McIntosh

MODEL NUMBER: C 8, C 11, C 22

DATE: APRIL 1965

MODIFICATION: Replace the selenium rectifier with silicon rectifiers. These silicon rectifiers have much longer life.

C 8

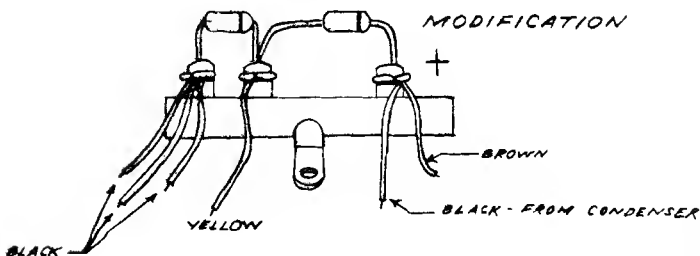
DESCRIPTION: The original selenium rectifier in the C 8 is replaced by two (2) silicon rectifiers; the original selenium rectifier in the C 11 and C 22 is replaced by four (4) silicon rectifiers. The rectifiers are McIntosh part number 070-014, or any 50 PIV 750 MA rectifiers.

PROCEDURE: The selenium rectifier is replaced by a terminal strip and the new silicon rectifiers are installed as shown in the following diagrams.

NOTE THAT TERMINAL STRIPS ARE REQUIRED
